ASSESSMENT REPORT

Stable Facilities at Royal Randwick Racecourse MP 10_0098 MOD 1

Figure 3: Proposed construction staging plan

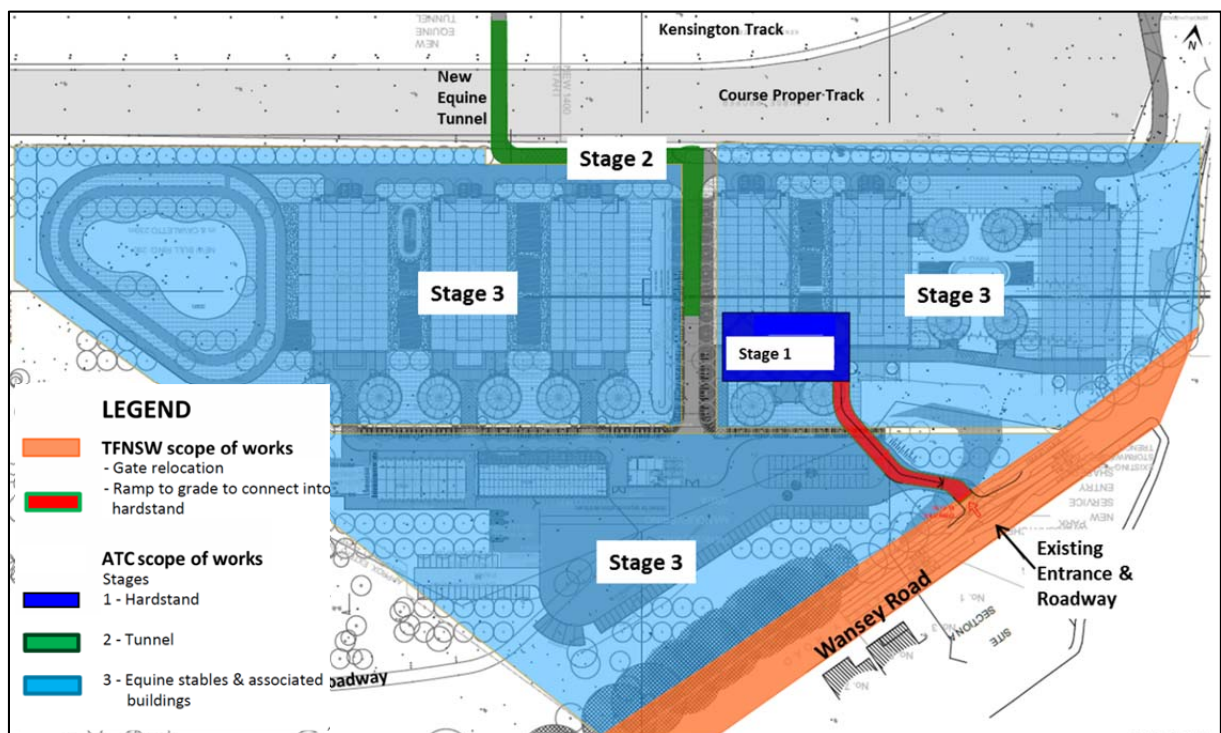
The proposed construction staging is illustrated in **Figure 3** and outlined in **Table 1**.

Stage 1 – Early Works (dark blue)	Early works to establish a construction hardstand zone on site that is to be used as a base for the site preparation works and remaining works in Stages 2 and 3.
Stage 2 – Equine Tunnel (green)	The tunnel is to start from the construction zone and extend under the track and infield. This stage involves the most extensive below ground excavation works and is therefore proposed prior to the primary building works to occur in Stage 3.
Stage 3 – Stables & associated buildings (light blue)	The stables, associated buildings, northern car park and landscaping works are to be undertaken as one stage prior to the final occupation and operation of the stables precinct.
Transport for NSW Works (orange)	The scope of works includes the relocation of Gate 10 and a new associated driveway to provide access to the stables precinct. Road works along Wansey Road and the intersection of Alison Road.

The proposal seeks to introduce a construction program that provides for the redevelopment to be undertaken in three (3) stages. This would facilitate the practical requirements of the construction program, account for the CSELR construction works and meet the operational needs of the RRR site.

The Department notes the proposed modifications would not result in any changes to the final development including the approved gross floor area, height, open space, car parking or vehicle access requirements of the approved redevelopment. As such there would be no change to the overall long term impacts of the proposal.

The proposed construction staging program is therefore supported as it would facilitate the construction requirements of the Proponent and would not result in any adverse environmental or amenity impacts.
